UNITED STATES PATENT AND TRADEMARK OFFICE

APPLICATION NO.	FILING DATE	FIRST NAMED INVENTOR	ATTORNEY DOCKET NO.	CONFIRMATION NO.
10/820,535	04/08/2004	Mehmet Aslan	50019.0225USU1	8319
23552	7590	10/19/2007		
MERCHANT & GOULD PC P.O. BOX 2903 MINNEAPOLIS, MN 55402-0903			EXAMINER VERBITSKY, GAIL KAPLAN	
			ART UNIT 2855	PAPER NUMBER
			MAIL DATE 10/19/2007	DELIVERY MODE PAPER

Office Action Summary

DETAILED ACTION

FIG. 23

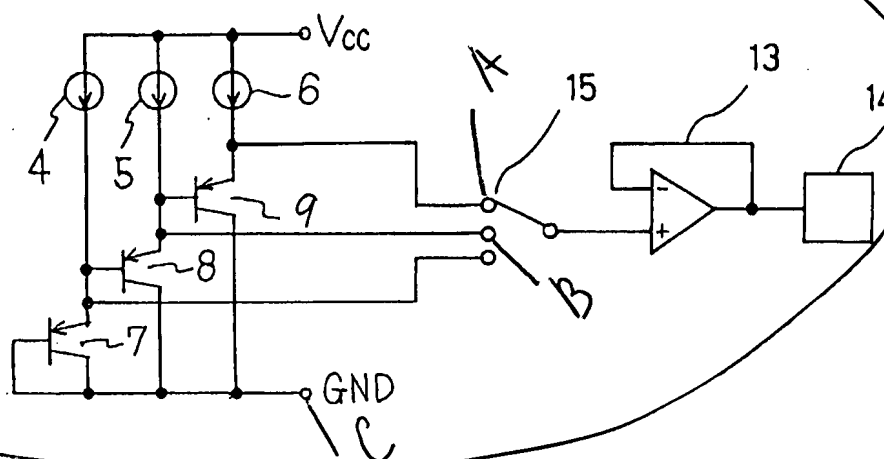
Machida discloses in Fig. 23 a device comprising a temperature sensor having two (three) transistors/ junction diodes (collocated on the same substrate/ support) whose first electrode is connected to a first terminal A, a second electrode B is connected to a third terminal C (Vground/ Vbias), wherein only one of the first and second terminals A, B is connected to a measurement circuit 13 (and pad 14) by means of a switch 15. It is inherent, that the third terminal is used for temperature measurements (The numerals A-C have been added by the Examiner, see attachment # 1 to the Office Action).

7, 8, 9 - bipolar for differential terminal
